UNITED STATES PATENT AND TRADEMARK OFFICE

10/042,057

Office Action Summary

DETAILED ACTION

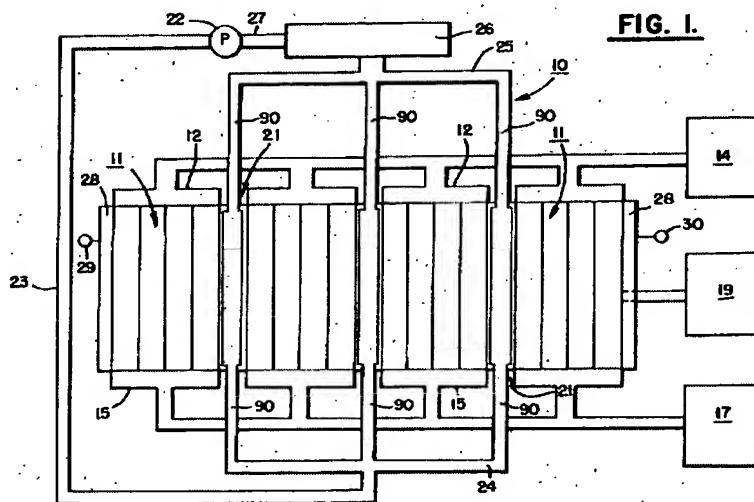
The reference is silent to at least two of the subsystems having respective cooling circuits, configured to be connected by series or parallel.

However, Wittel teaches that it is conventional to employ subsystems having respective cooling circuits in series/parallel as illustrated in Figure

in order to maximize heat transfer from the fuel cell stack to the coolant without undue manufacturing and assembly tolerances and to avoid shunt currents without the need for additional electrical isolation form adjacent cells of the fuel cell stack. See column 3, lines 5-25.

However, Wittel teaches that it is conventional to employ subsystems having respective cooling circuits in series/parallel illustrated as in Figure 1:

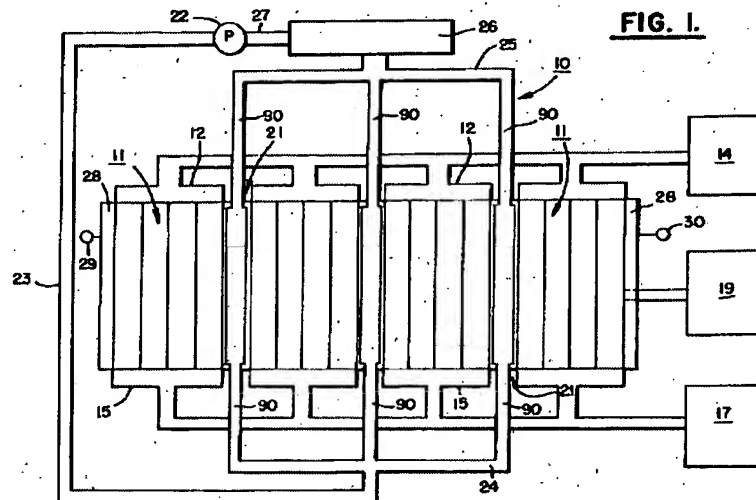
The reference is silent to at least two of the subsystems having respective cooling circuits, configured to be connected by series or parallel.

in order to maximize heat transfer from the fuel cell stack to the coolant without undue manufacturing and assembly tolerances and to avoid shunt currents without the need for additional electrical isolation from adjacent cells of the fuel cell stack. See column 3, lines 5-25.
